# HISTORIC AND DESIGN REVIEW COMMISSION

# October 19, 2022

HDRC CASE NO: ADDRESS: LEGAL DESCRIPTION: ZONING: CITY COUNCIL DIST.: DISTRICT: APPLICANT: OWNER: TYPE OF WORK: APPLICATION RECEIVED: 60-DAY REVIEW:	2022-500 311 W ROSEWOOD AVE NCB 6532 BLK 12 LOT 17, 18, E 2 IN OF 16 & W 24.2 FT OF 19 R-5, H 1 Monte Vista Historic District DORIN REGUS/STONE OAK RENOVATIONS Roberto Varela/VARELA PROPERTIES LLC Window replacement, fenestration changes September 15, 2022 Not applicable due to City Council Emergency Orders
60-DAY REVIEW: CASE MANAGER:	•

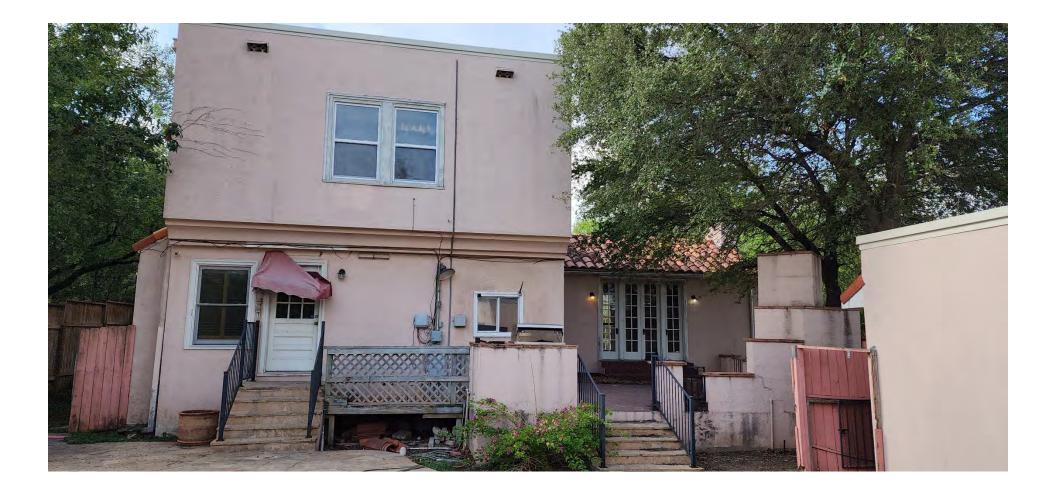
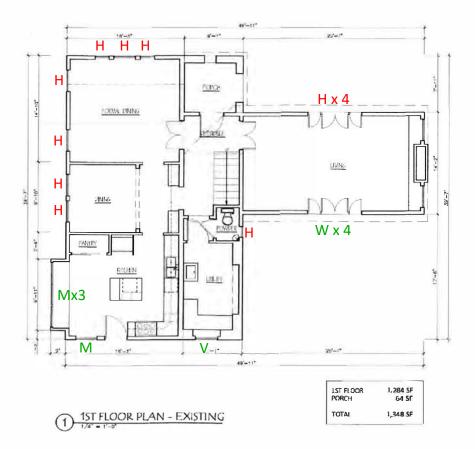
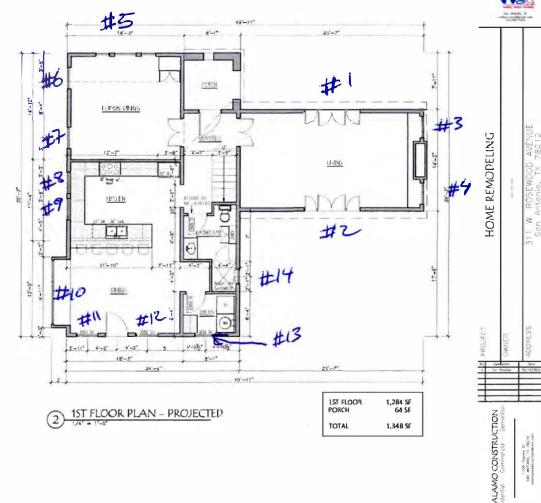
- H = Historic wood sash, to be retained
- H = Historic wood sash, but beyond repair
- V = Vinyl sash, eligible for replacement
- M = Metal sash, eligible for replacement
- W = Modern wood, eligible for replacement

1.2

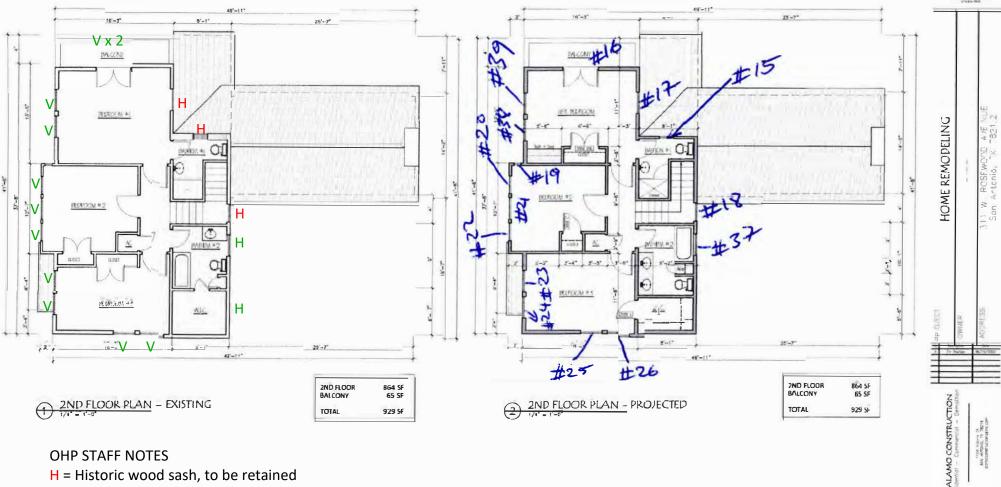
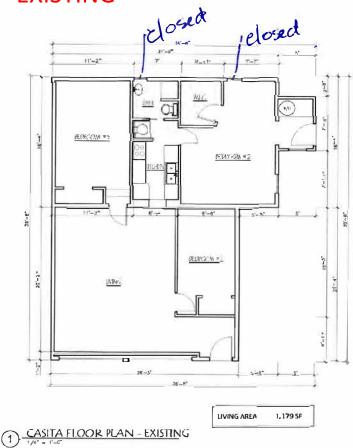
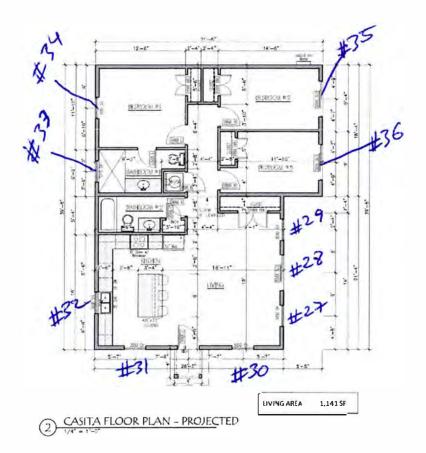
- H = Historic wood sash, to be retained
- H = Historic wood sash, but beyond repair
- V = Vinyl sash, eligible for replacement
- M = Metal sash, eligible for replacement
- W = Modern wood, eligible for replacement
